ARCHITECTURAL REVIEW COMMITTEE MEMORANDUM

DATE: JULY 6, 2021 UNFINISHED BUSINESS

SUBJECT: DENISE BERRY, OWNER, REQUESTING A MAJOR ARCHITECTURAL APPLICATION TO CONSTRUCT A NEW 1,611-SQUARE FOOT SINGLE-FAMILY RESIDENCE, AND AN ADMINISTRATIVE MINOR MODIFICATION APPLICATION TO REDUCE REQUIRED SETBACKS OF THE DEVELOPMENT LOCATED AT 105 WEST SAN MARCO WAY, ZONE R-1-C, SECTION 4 (CASE 3.4225 MAJ & 7.1628-AMM). (AP)

02-17-21
 SITE PLAN

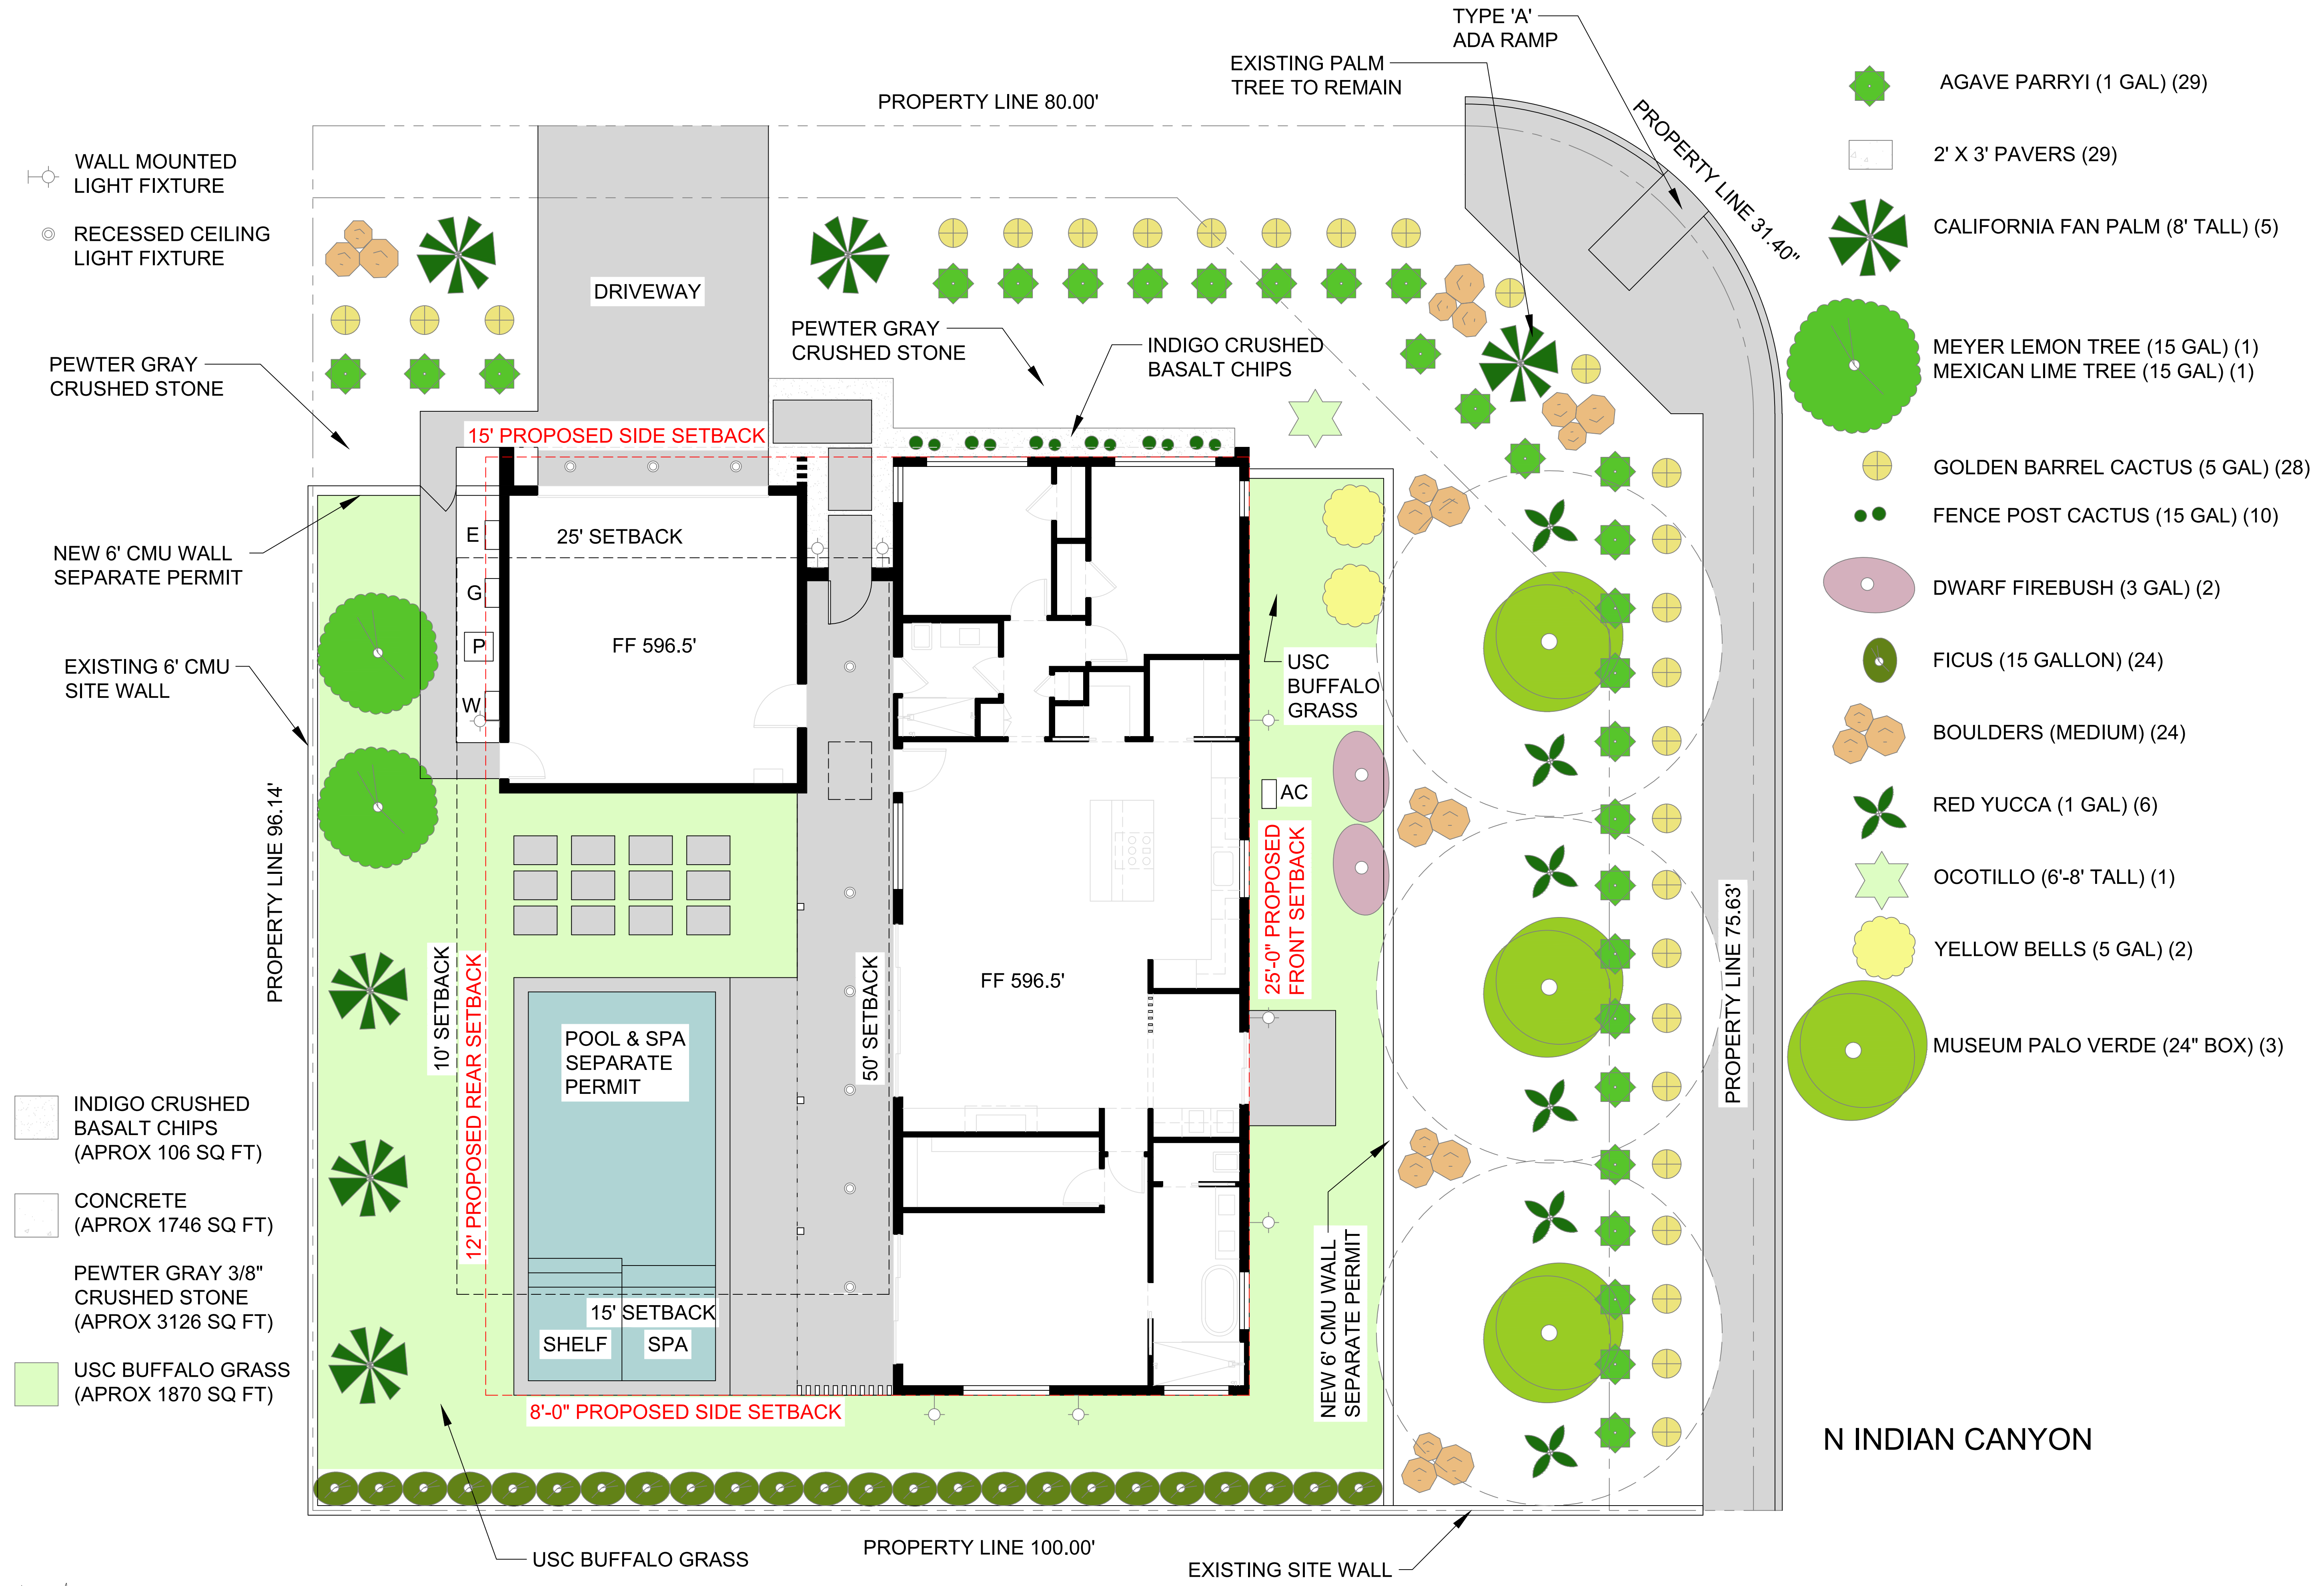
- Enhance landscape on both street frontages
- Consider alternative to white rock
- Show roof penetrations and minimize roof clutter where possible
- Consider a different roof material for the sloped area.

Member McCoy said the landscape plan needs improvement on both street frontages, noting specific concerns with white rock, the dividing rock mound, the flanking palm trees.

ARC Comments	Proposed Changes
1	Landscape	Landscape has been significantly enhanced from 50 plants to 113 plants, along the street frontages. Proposed landscaping includes: 29 Agave, 5, California Fan Palms, a lemon and lime tree, 28 Golden Barrel Cactus, 10 Fence Post Cactus, Dwarf Firebush, 24 Ficus, 6 Red Yucca, an Ocotillo, 2 Yellow Bells and 3 Palo Verde
2	Hardscape	The white rock has been replaced with crushed Pewter Gray rocks. A crushed Indigo Basalt rock will be placed in the planter areas along the building frontage.
3	Roof Material	The entire roof will remain a spray foam white.

02-17-21
ROOF PLAN

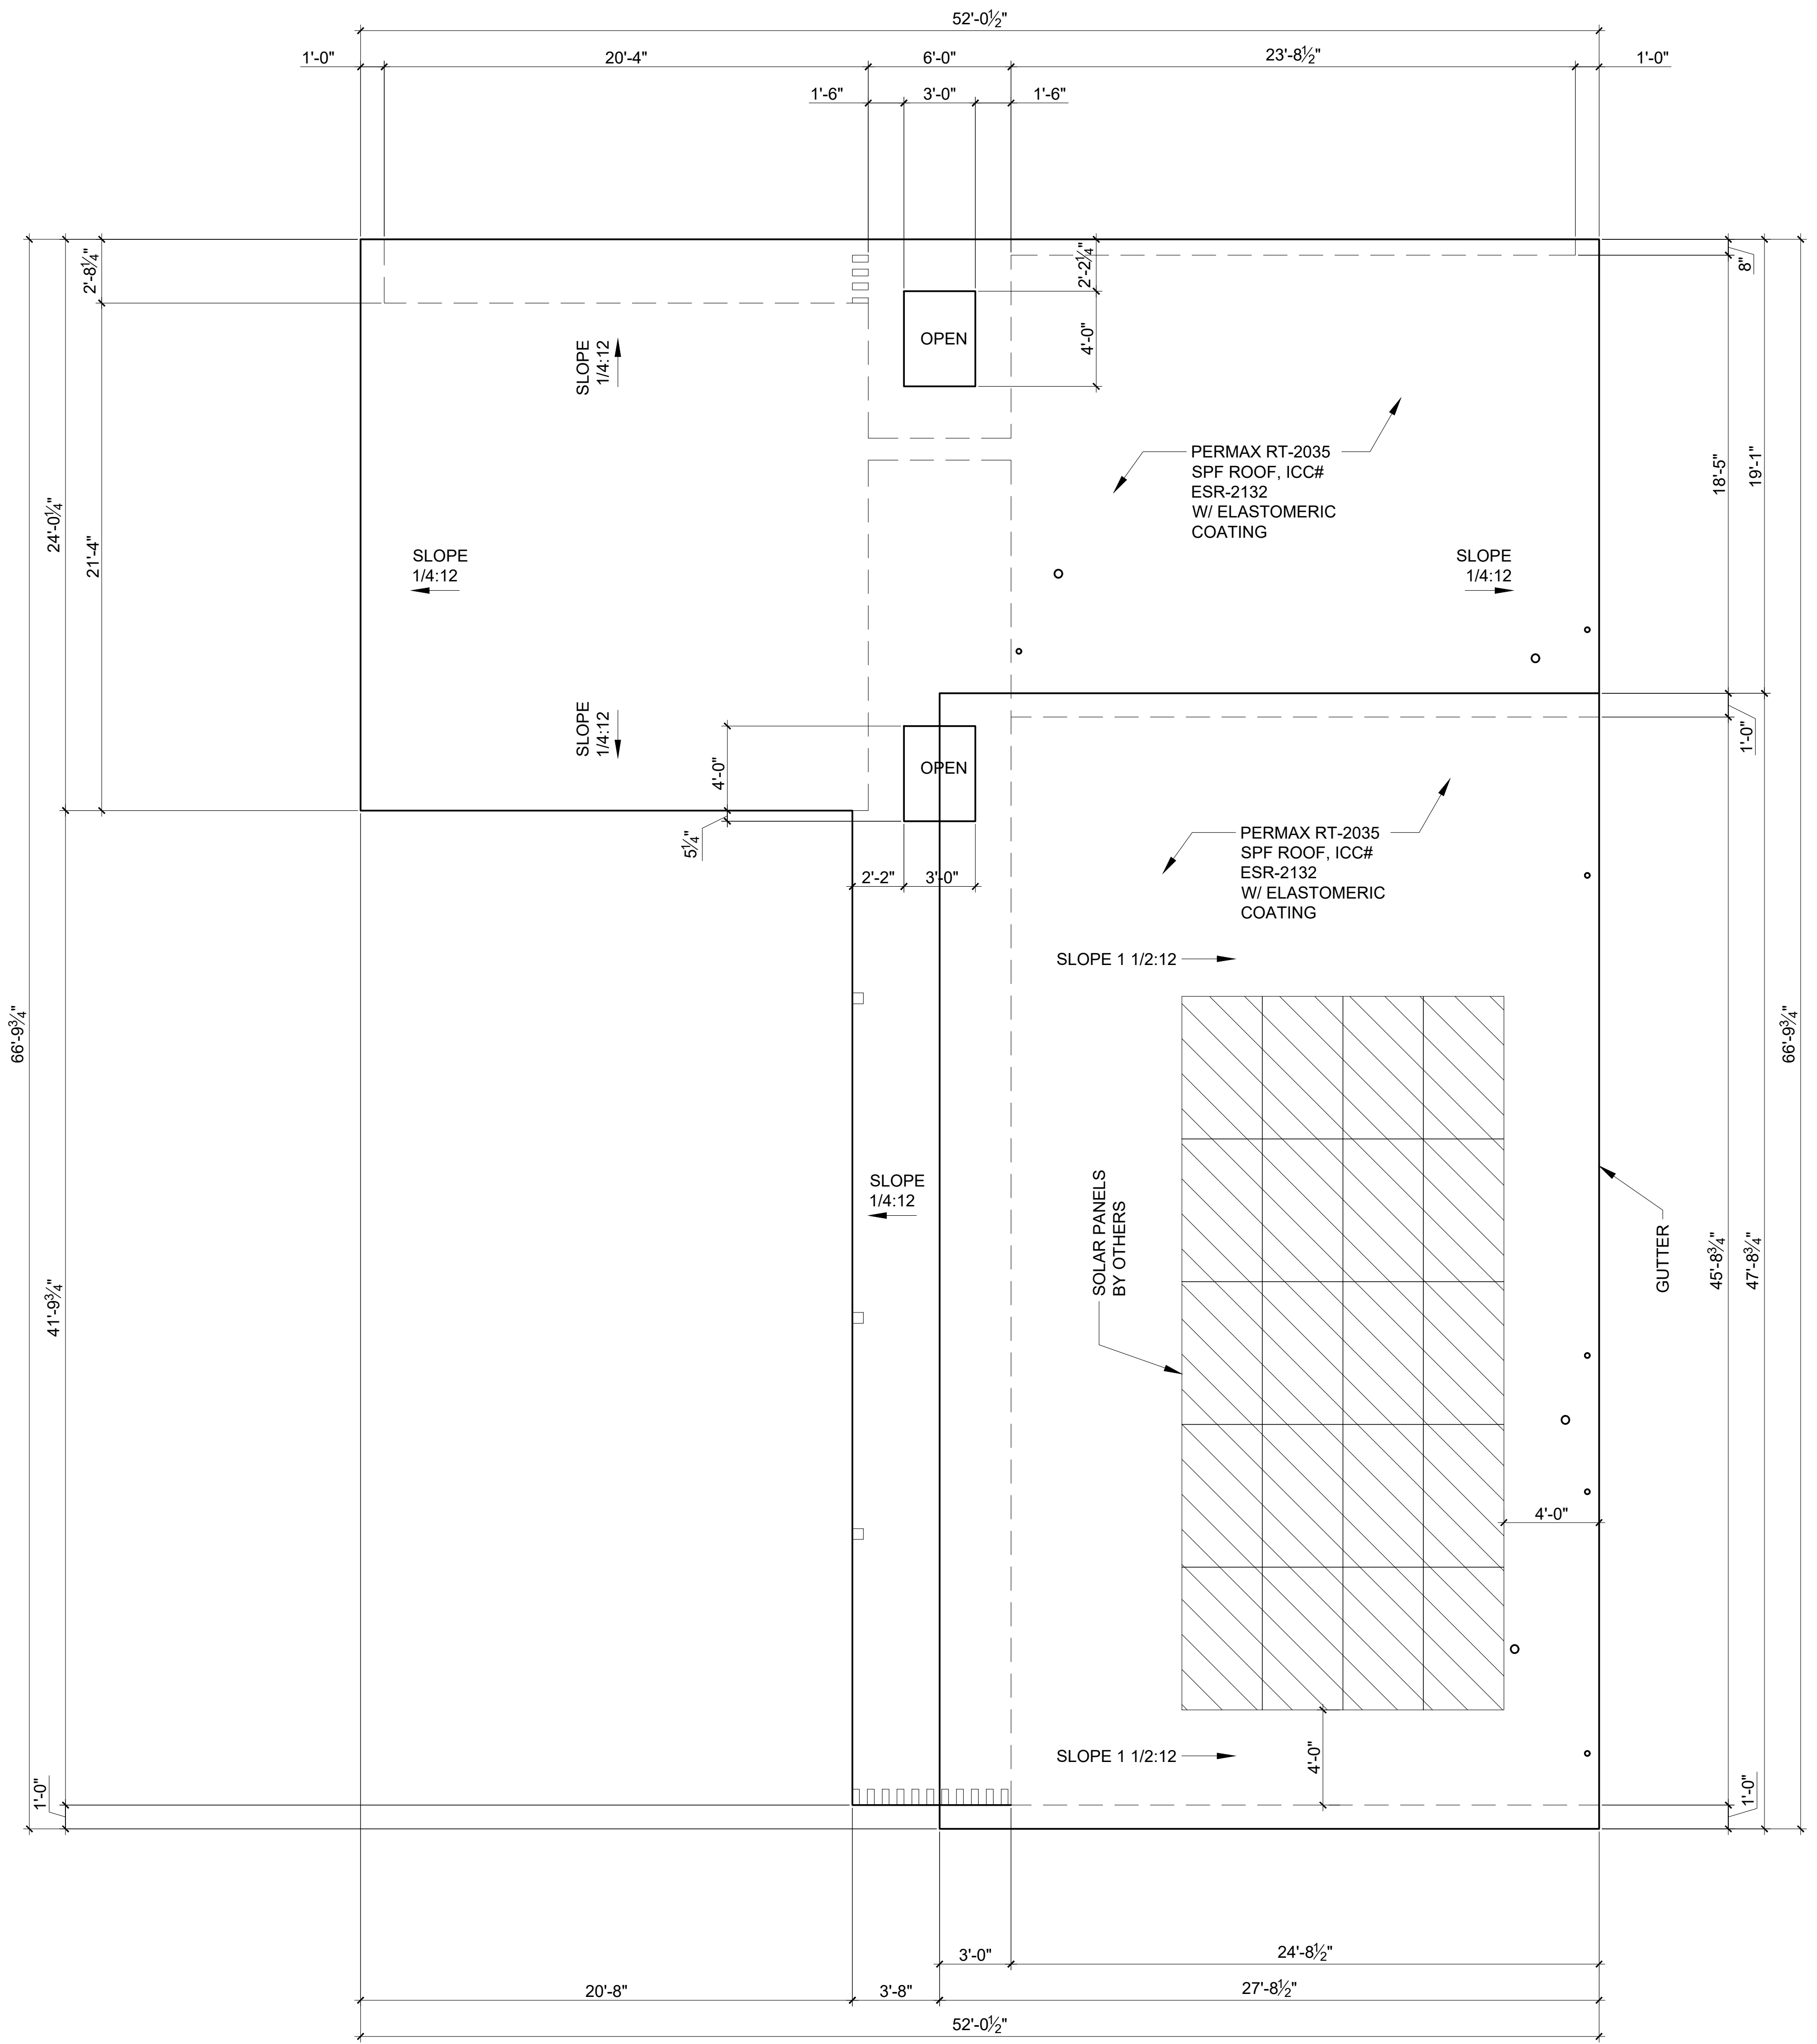
Member Lockyer agreed landscape needs improvement. He asked that the renderings show the roof penetrations. He suggested alternating the slope roof material, possibly with standing seam roof.
